Certificate of Appropriateness

Property	2019 N. PALMER ST.	Brewers Hill Historic District
Description of work	Install new GAF Timberline Natural Shadow shingles in slate color. Restore two original window openings on first story of front elevation and install new wood windows in them. Tuck-point front elevation as needed.	
Date issued	6/10/2014	PTS ID 95437 COA, window restoration, tuckpointing, new roof

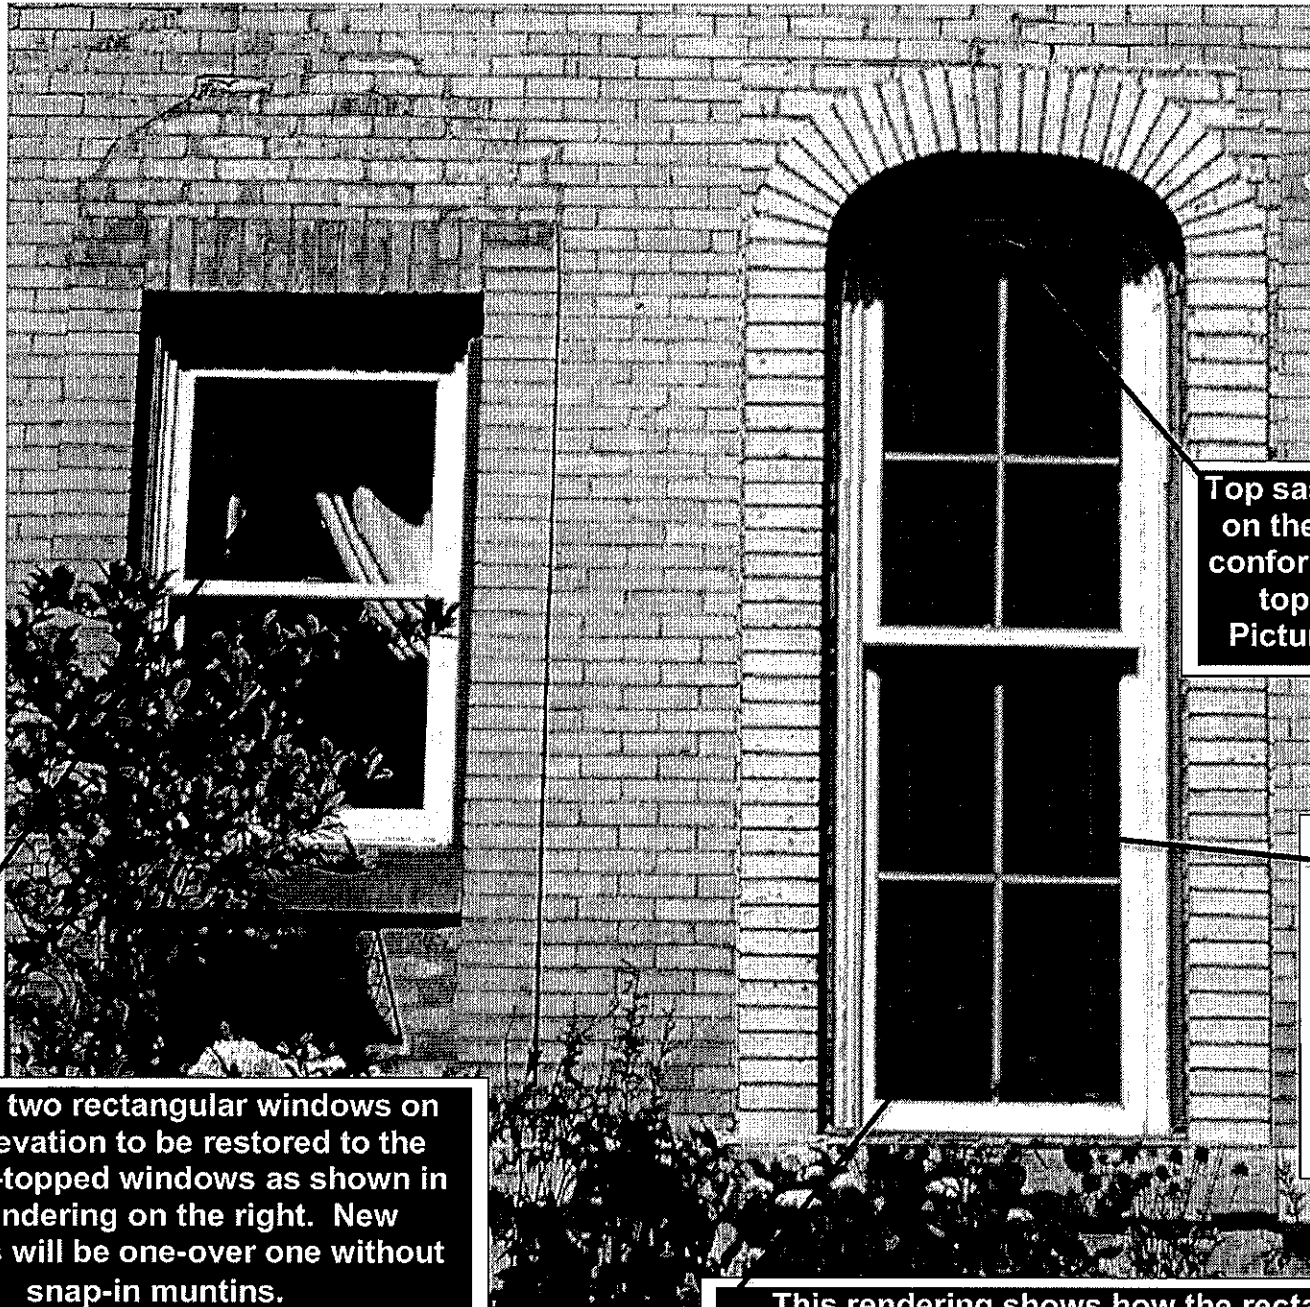
Existing two rectangular windows on front elevation to be restored to the elliptical-topped windows as shown in the rendering on the right. New windows will be one-over one without snap-in muntins.

Top sash must be cured on the INSIDE edge to conform to the elliptical topped windows. Pictured here the top

No muntins and snap-in muntins will be removed from existing windows on the second story of the front elevation

This rendering shows how the rectangular windows will be modified on the first story of the front elevation to match the original design.

The new wood windows will have semi-elliptical tops to match the second story front windows. No vinyl, vinyl-clad, aluminum, aluminum-cad, fiberglass or steel windows are permitted. New windows will be one-over-one with no muntins. Existing snap-in muntins on second floor windows of front elevation will be removed. The new window openings will be fitted with PRESSED cream brick arches and field brick. New mortar must match the original in terms of color, texture, hardness joint width and joint finish. Mortar no harder than type K should be used to match the mortar used during the 1860s when the house was built. Please see the masonry chapter in the city's book "As Good As New" for more information on why the proper hardness mortar is crucial to a lasting job and one that will not damage the historic brickwork.
